# **OFFICIAL MEETING NOTICE AND AGENDA**

**RE: Exclusively Roses Inc., 221 Business Park Circle – Building Addition**

I have completed a final review of the proposed building addition for Exclusively Roses, 221 Business Park Circle, Stoughton, WI. 53589 – plans received 12/12/14. A joint meeting of the Planning Commission and Business Park North Committee will be on Monday December 15, 2014 of which you will receive notice.

**EXCLUSIVELY ROSES - BUILDING ADDITION**  
 GRADING AND EROSION CONTROL PLAN  
 PAGE: 2 OF 4  
 DATED: DECEMBER 11, 2014

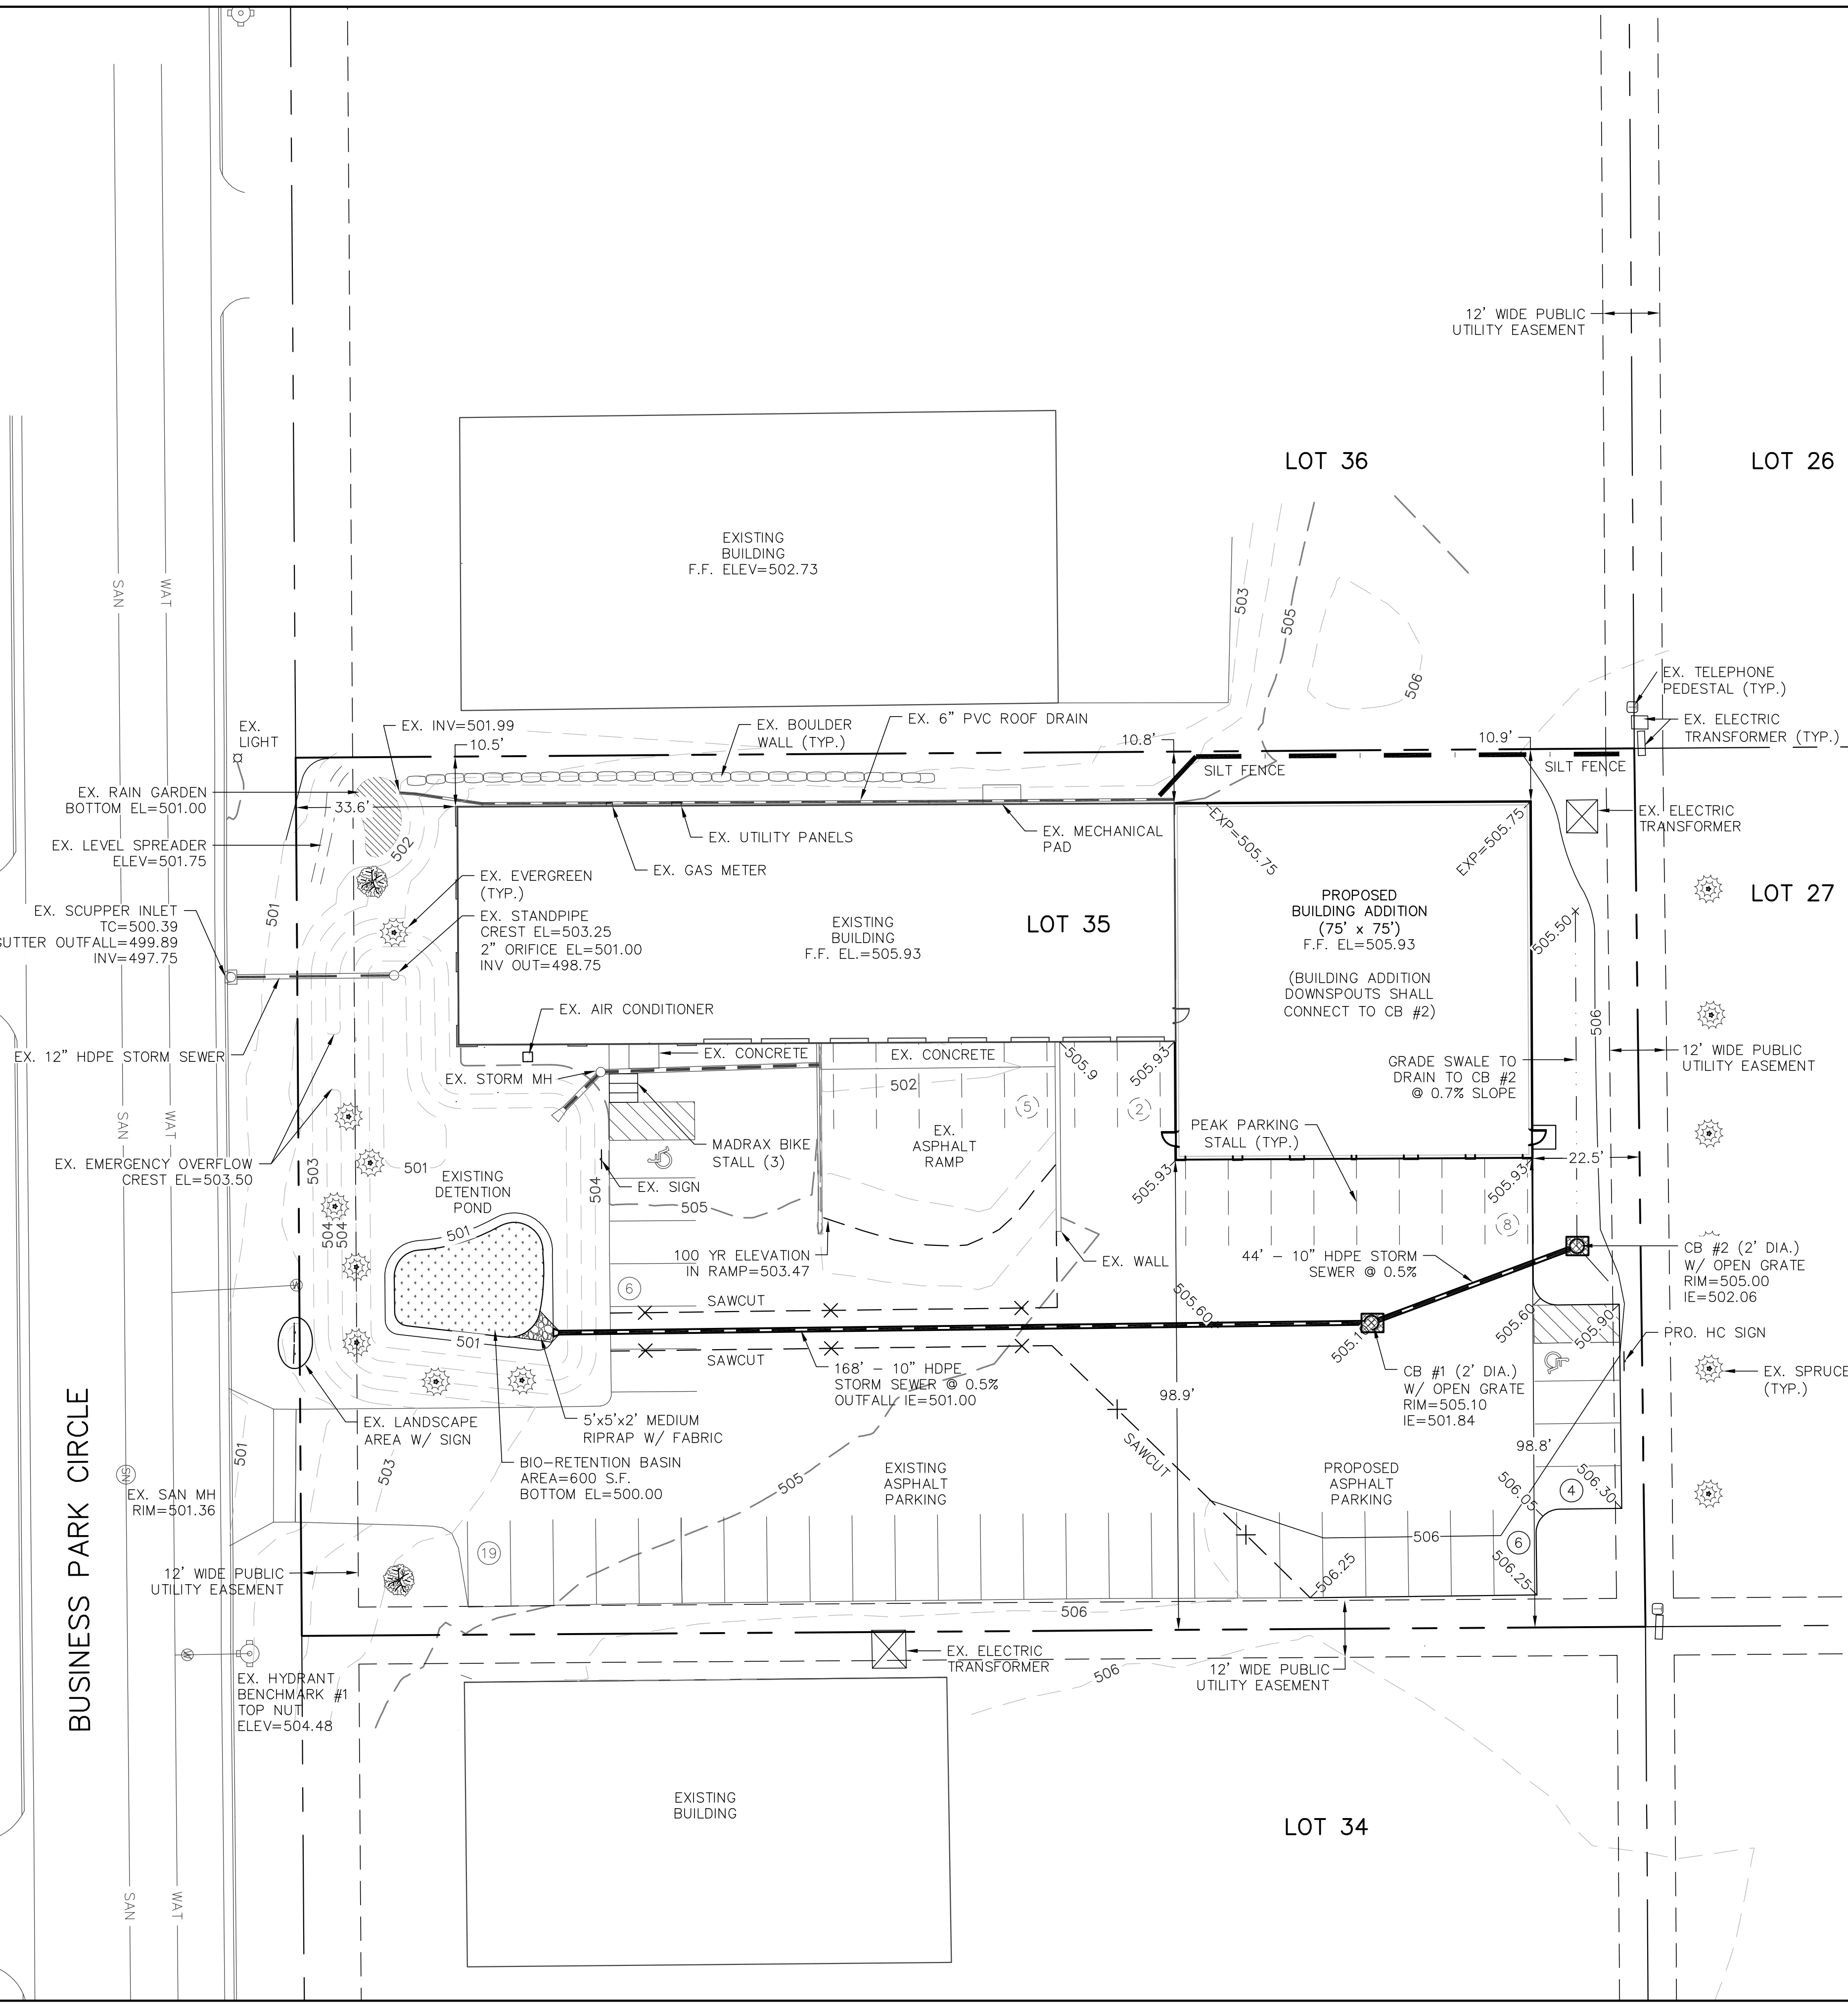
1. Plan Submittal
  - a. Name and mailing address of developer/owner. **Provided.**
  - b. Utilities and utility right of way easements. **Easements are shown. Elevation alterations of 6-inches or more within any easement need to be approved by Stoughton Utilities. The grade appears to be changing within the front 12-foot easement.**

- e. Clearing, grading, and drainage plan showing proposed clearing limits, existing and proposed contours at two foot intervals. **The provided grading plan with one foot contours is sufficient to meet this requirement.**

**EXCLUSIVELY ROSES – BUILDING ADDITION**  
LANDSCAPE PLAN  
PAGE: 3 OF 4  
DATED: DECEMBER 11, 2014

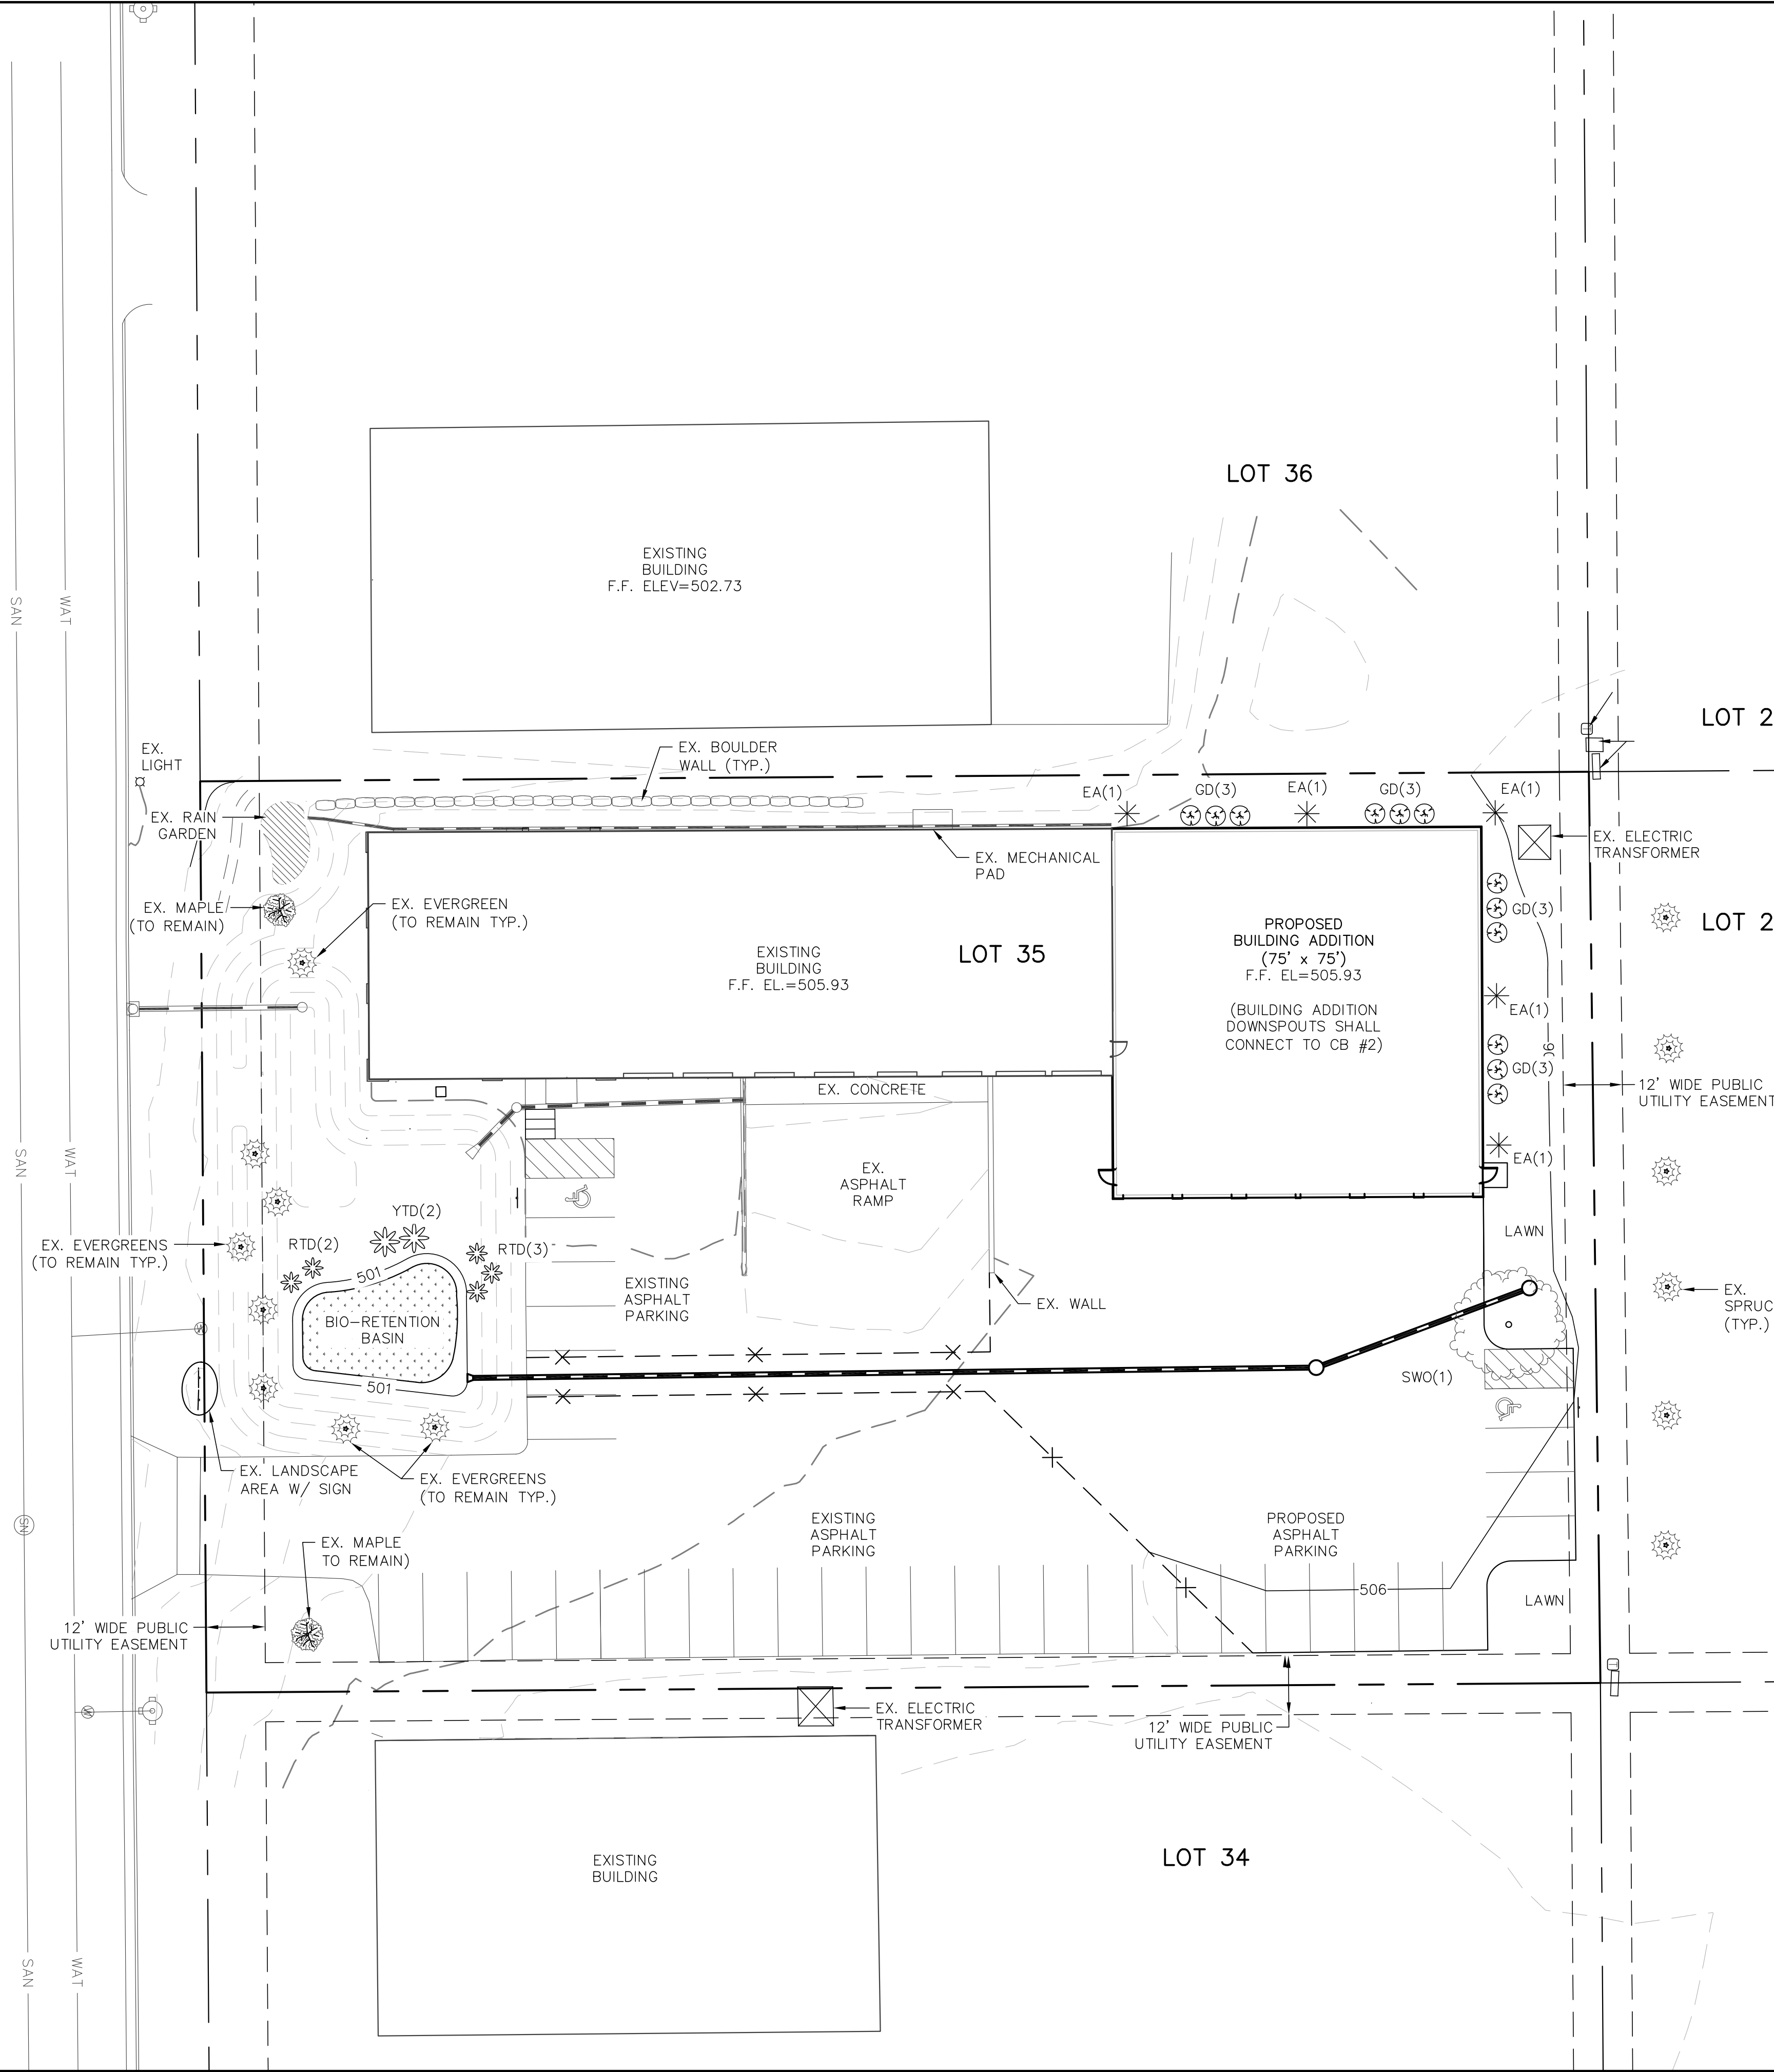
**100 landscaping points are required for the building foundation and such landscaping shall be located so at maturity the plants drip line is within 10 feet of the foundation. The plan meets this requirement.**

**30 points are required for the 10 newly created parking stalls. The plan meets this requirement.**
